CERTIFICATE OF APPROPRIATENESS

Property: 1051 Heights Boulevard, Reserve A, Block 1, Heights Central Station

Proposal: Alteration: Sign

1051 Heights Blvd No.250 Houston Heights South

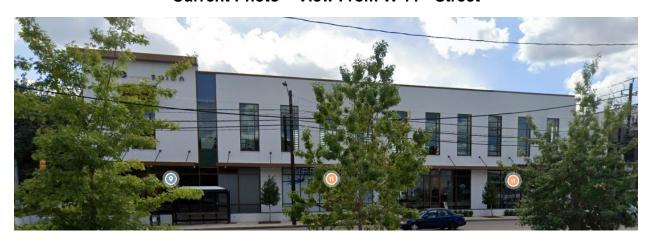
S	D	NA		S - satisfies D - does not satisfy NA - not applicable
			(1)	For an alteration, rehabilitation, or restoration that does not require the removal or replacement of the structural elements, not including the foundation, within 67 percent of the structure:
\boxtimes				(a) The proposed activity must recognize the building, structure, object or site as a product of its own time and avoid alterations that seek to create an earlier or later appearance; and

(b) The proposed activity must match the architectural features, materials, and character of either the existing noncontributing structure or the contributing structures within the context area. Houston Heights Design Guidelines, p. 4-42 "Reverse-channel (backlit) individual letters mounted on the building are appropriate."
